# **Determination 2019/021**

# Regarding compliance with Clause D1 of a staircase to the mezzanine level of a farm building at 2/149 Golden Valley Road, Waihi

## **Summary**

Figure 3: East/west section of the eastern end

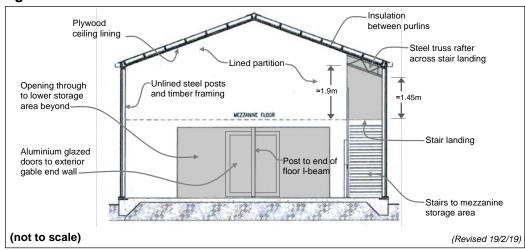
- In regard to D1/AS1 (see Appendix A1.7):
    - o the stair landing height slopes down from about 1.8m to 1.5m, which does not comply with the minimum 2m in paragraph 1.4 of D1/AS1.

3.5.2 In discussion with the authority, the designer noted that the handrail profiles in Figure 26 referred to by the authority were for 'private and common stairs', rather than the 'service stair designed' for the shed. In regard to clearance at the top of the stairs, it was observed that the head height (1450mm to 1893mm) beneath the steel truss at the top of the stairs (see Figure 3) is below the minimum 2m in section 1.4. The parties again discussed the limits on application, but the authority maintained its position and was 'not prepared to accept the limits on the application of D1.2.1' as being applicable to the objective of D1.1(a) (see Appendix A1.4).

Figure 4: Stair balustrade

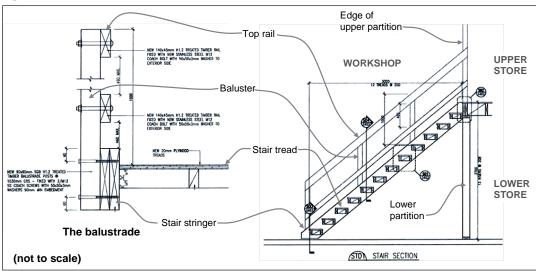
- 3.5.1 The authority responded to the revised drawings by issuing RFI(6) on 27 February 2019, which raised the matter of non-compliance of the stair with the Acceptable Solution D1/AS1 (see Appendix A1.7) and stated:
  - 1. The design does not show proof of compliance with D1/AS1:
    - a) The handrail does not comply with D1/AS1 Section 6 figure 26A, graspable handrail, as proposed [the relative width] is 185mm.
       Please revise.
  - 2. Drawing A220 shows the height clearances at the top of the stairs. These height clearances do not comply with D1/AS1 section 1.4. Please revise.

- o the proposed handrail is a 140 x 45mm timber rail resulting in a handrail that is 135mm at the balustrades, which does not accord with paragraph 6.0.7 / Figure 26A of D1/AS1.

- 5.3.12 As an outbuilding, the shed is excluded from the functional requirement to provide 'reasonable and adequate access to enable safe and easy movement of people'. Considering the purpose of the Building Code set out in section 16 of the Act (refer paragraph 5.3.1), and taking into account the discussion above, I conclude that the shed is not required to achieve the performance criteria in Clause D1.
- 5.3.13 The authority's concerns relate to the landing height and that the handrail as designed is not graspable. While not a matter of compliance, because I have concluded the shed is not required to meet the performance criteria in Clause D1, I suggest the applicants consider marking (highlighting) the lower edge of the truss to provide warning of the height restriction and improvements to the profile of the handrail and/or its fixing.
